To:	All plan holders	From:	Tracy Blocker, Division
Pages:	85	Phone:	515-344-6279
Re:	Har892022C Nutrient Reduction Wetland (Bid 26-09)	Date:	August 21, 2026

Subject: **Addendum No. 1** to Bid Documents
HAR892022C Nutrient Reduction Wetland Project – Bid No. 26-9
Hardin County, Iowa

Project Description and Location: Har892022C Nutrient Reduction Wetland Project
Section 22, Township 89 North, Range 20 West
Hardin County, Iowa

PROPOSED TILE

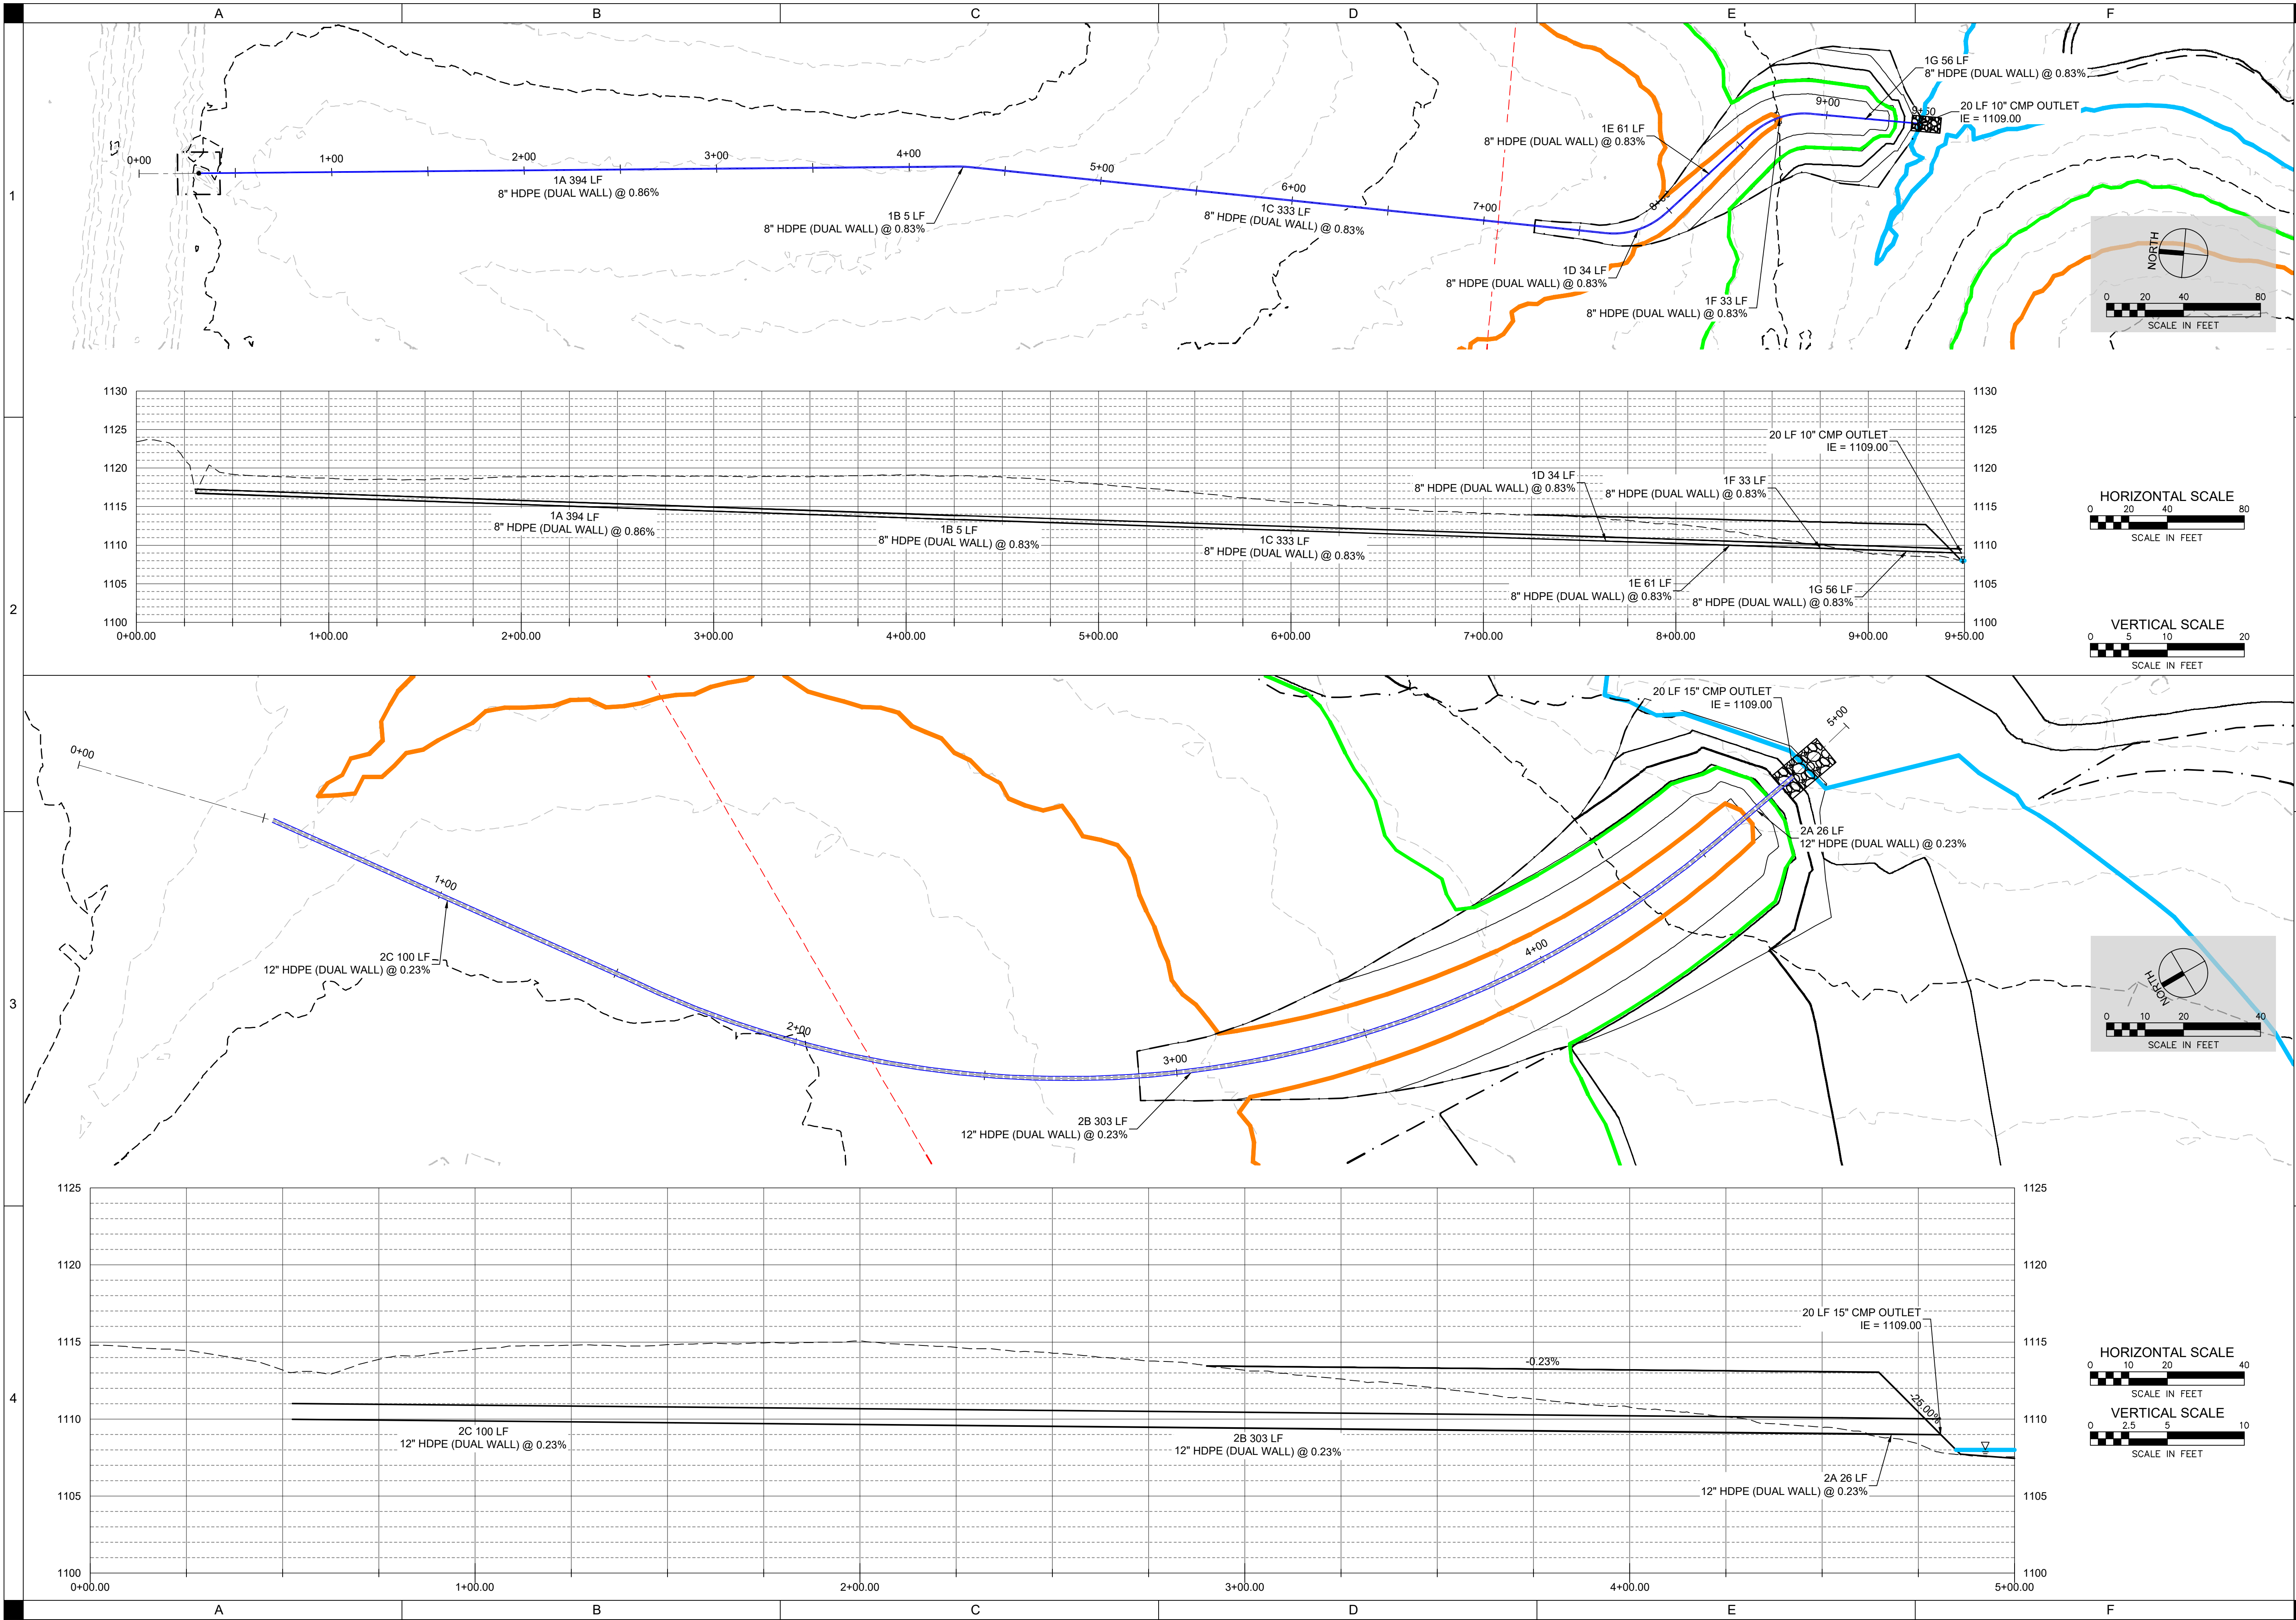
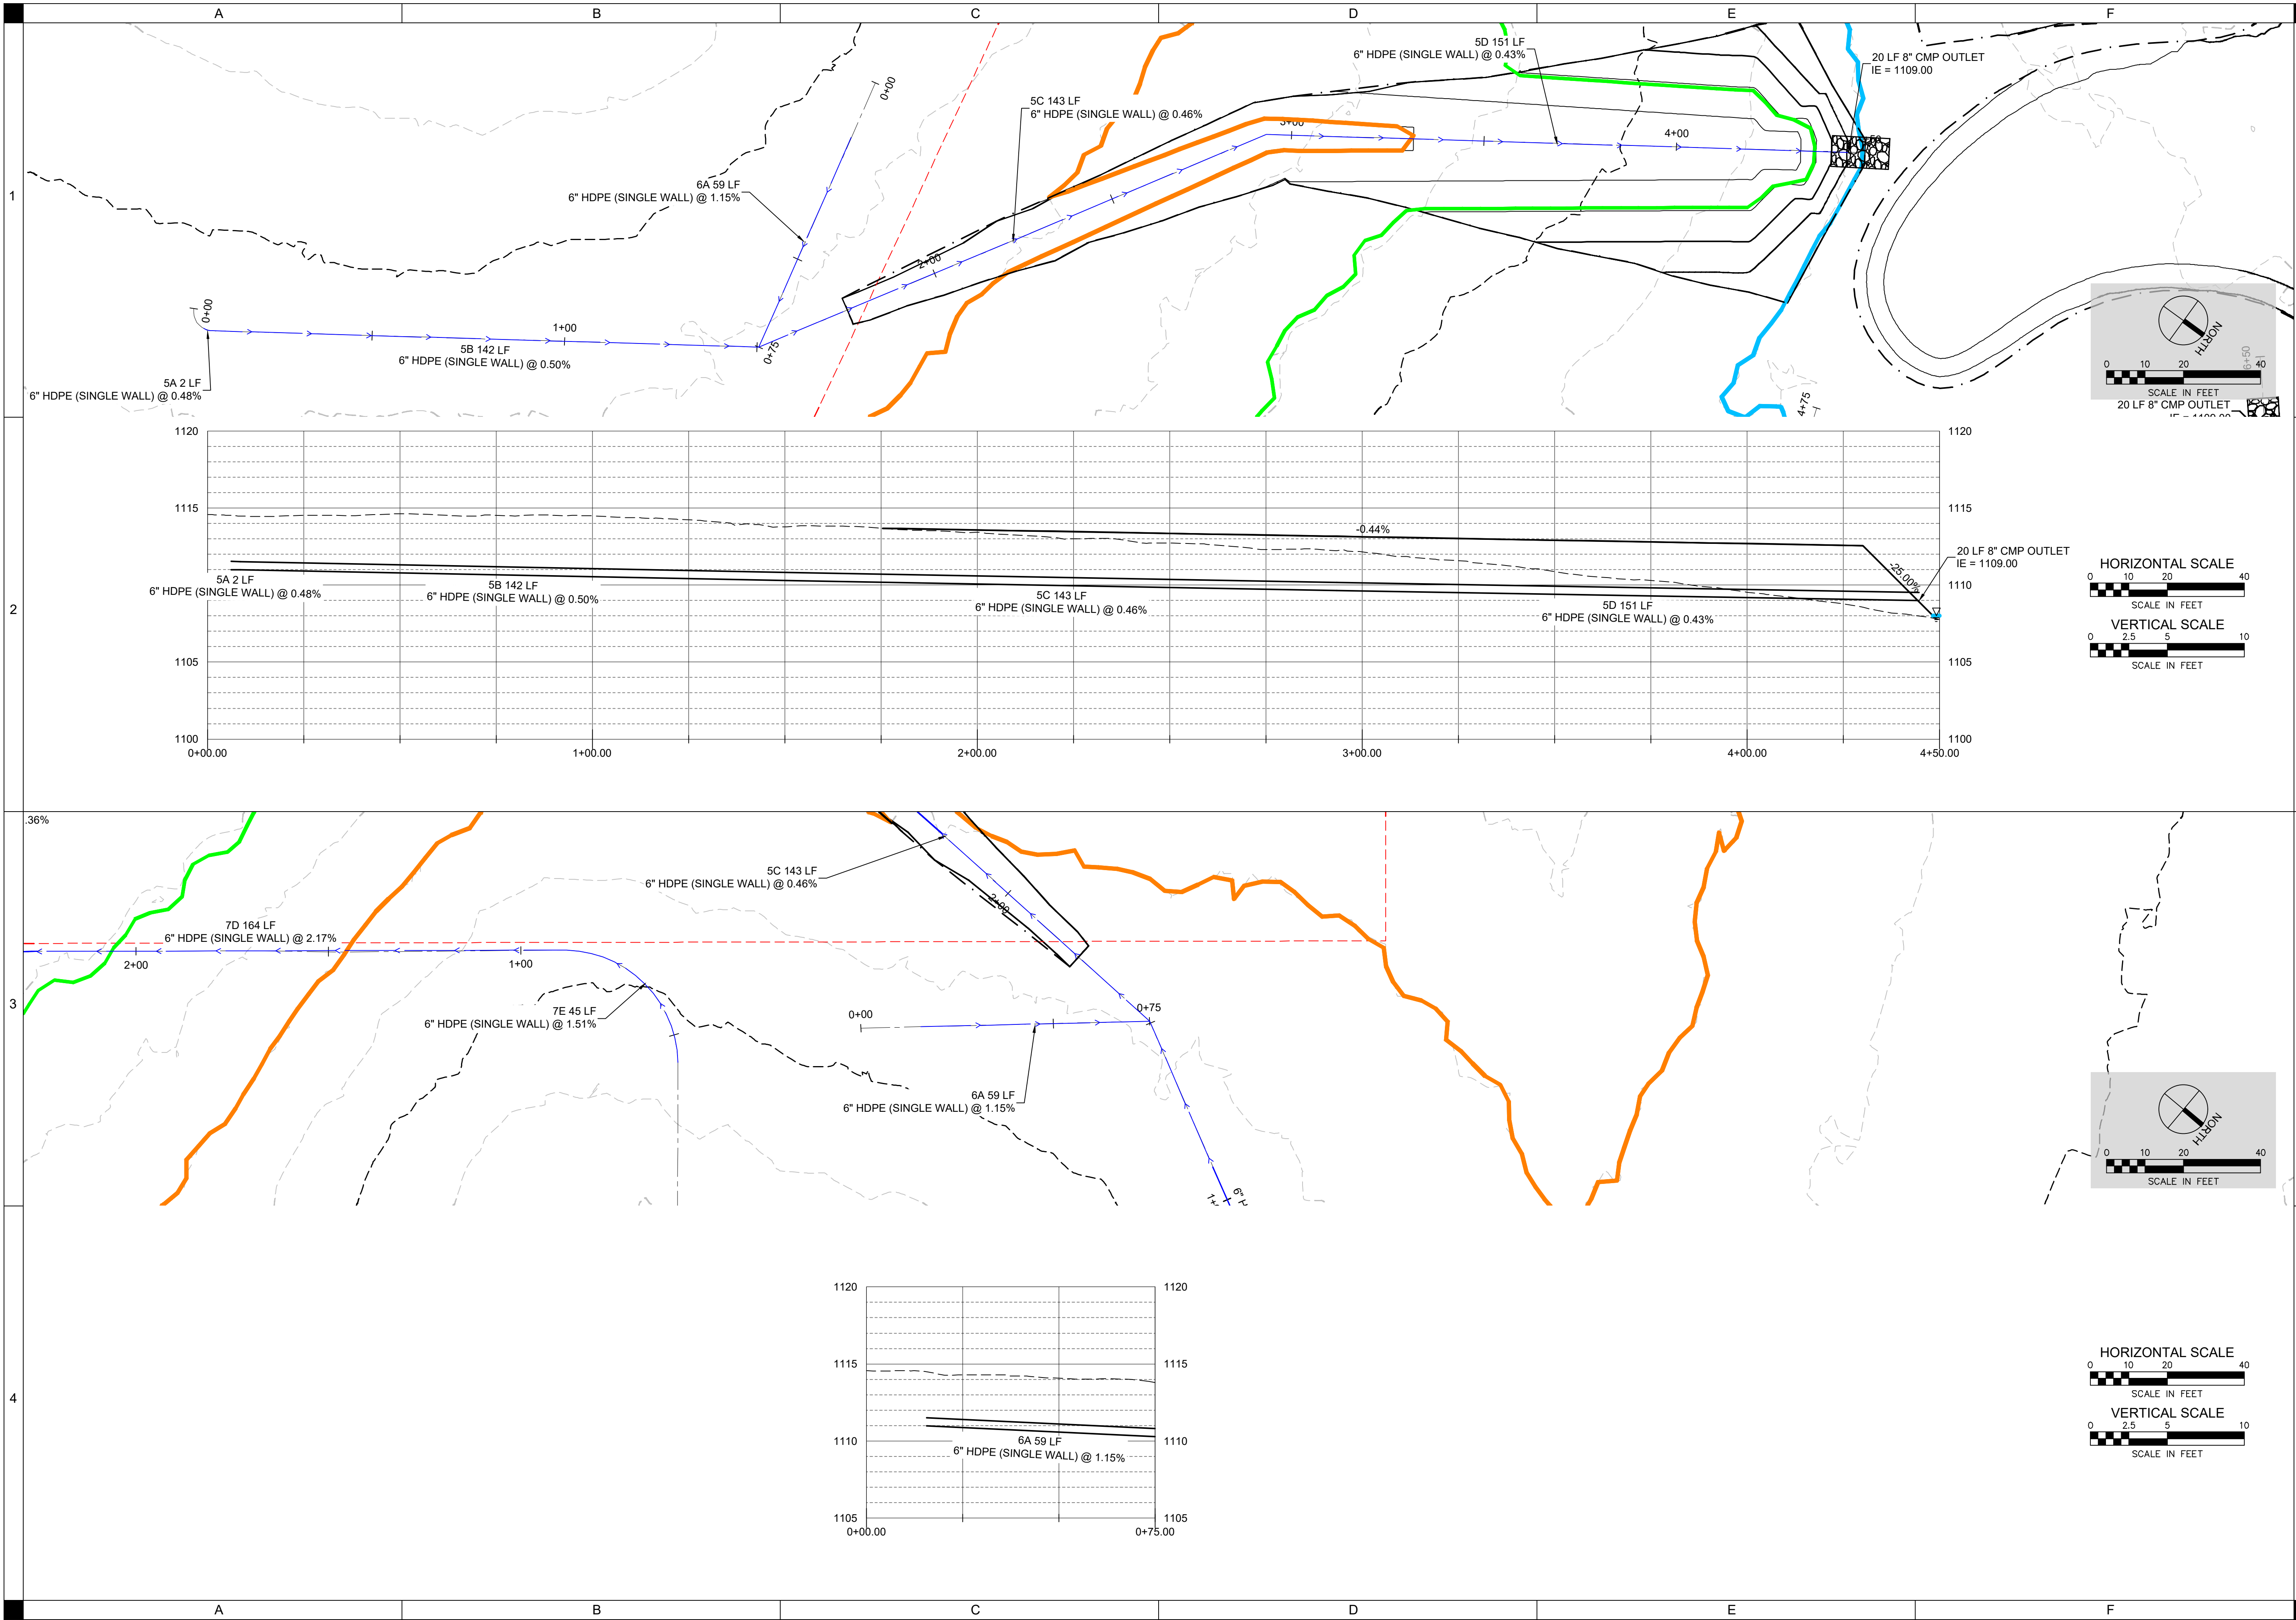
- Plans have been updated to add 4" tile, modify the quantities and material specifications for the 8" tile to include dual and single wall pipe, and to add 2" clean rock at the construction entrance. There are three new work items, Bid Item #15 "4" HDPE tile", Bid item 18 "8" HDPE single wall" and Bid Item #27 "2" clean rock" being included. As a result, the numbering of the bid items has also changed. Attached are the revised set of Plans.

1. Remaining 8" tile (Tile 4) will be updated to single wall
 - iv. All 6-Inch tile will be changed to single wall tile.
 - v. Landowner would like to add a few 4" laterals to supplement drainage where tile is removed outside this easement to the east. Sara we can discuss this further when you have a moment.

14	IA CS-031	36" RCP DRAWDOWN WETLAND OUTLET PIPE: THIS ITEM INCLUDES ALL LABOR, EQUIPMENT, AND MATERIALS REQUIRED FOR THE EXCAVATION, PLACEMENT OF THE REINFORCED CONCRETE PIPE, SUPPORT BLOCKS, OUTLET CRADLE , ANTI-SEEP COLLARS, AND BACKFILL.
15	IA CS-046	4" CORRUGATED PROFILE WALL (NON-PERFORATED SINGLE WALL) POLYETHYLENE PIPE: THIS ITEM INCLUDES THE MATERIAL, EXCAVATION, PLACEMENT, JOINTING, AND BACKFILL OF THE 4" SINGLE WALL NON-PERFORATED HDPE DRAIN TILE. SEE SHEET C202 FOR LENGTHS, LOCATIONS AND ELEVATIONS.
16	IA CS-046	6" CORRUGATED PROFILE WALL (NON-PERFORATED SINGLE WALL) POLYETHYLENE PIPE: THIS ITEM INCLUDES THE MATERIAL, EXCAVATION, PLACEMENT, JOINTING, AND BACKFILL OF THE 6" SINGLE WALL NON-PERFORATED HDPE DRAIN TILE. SEE SHEET C202 FOR LENGTHS, LOCATIONS AND ELEVATIONS.
17	IA CS-046	8" CORRUGATED PROFILE WALL (NON-PERFORATED, SINGLE WALL) POLYETHYLENE PIPE: THIS ITEM INCLUDES THE MATERIAL, EXCAVATION, PLACEMENT, JOINTING, AND BACKFILL OF THE 8" SINGLE WALL NON-PERFORATED HDPE DRAIN TILE. SEE SHEET C202 FOR LENGTHS, LOCATIONS AND ELEVATIONS.

18	IA CS-046	8" CORRUGATED PROFILE WALL (NON-PERFORATED, DUAL WALL) POLYETHYLENE PIPE: THIS ITEM INCLUDES THE MATERIAL, EXCAVATION, PLACEMENT, JOINTING, AND BACKFILL OF THE 8" DUAL WALL NON-PERFORATED HDPE DRAIN TILE. SEE SHEET C202 FOR LENGTHS, LOCATIONS AND ELEVATIONS.
19	IA CS-046	10" CORRUGATED PROFILE WALL (NON-PERFORATED, DUAL WALL) POLYETHYLENE PIPE: THIS ITEM INCLUDES THE MATERIAL, EXCAVATION, PLACEMENT, JOINTING, AND BACKFILL OF THE 10" DUAL WALL NON-PERFORATED HDPE DRAIN TILE. SEE SHEET C202 FOR LENGTHS, LOCATIONS AND ELEVATIONS.
20	IA CS-046	12" CORRUGATED PROFILE WALL (NON-PERFORATED, DUAL WALL) POLYETHYLENE PIPE: THIS ITEM INCLUDES THE MATERIAL, EXCAVATION, PLACEMENT, JOINTING, AND BACKFILL OF THE 12" DUAL WALL NON-PERFORATED HDPE DRAIN TILE. SEE SHEET C202 FOR LENGTHS, LOCATIONS AND ELEVATIONS.
21	IA CS-046	STOP LOG STORAGE STRUCTURE: THIS ITEM INCLUDES ALL LABOR, EQUIPMENT, AND MATERIALS FOR THE PLACEMENT OF STOPLOGS, STOP LOG REMOVAL TOOLS, AND STOP LOG STORAGE STUCTURE.
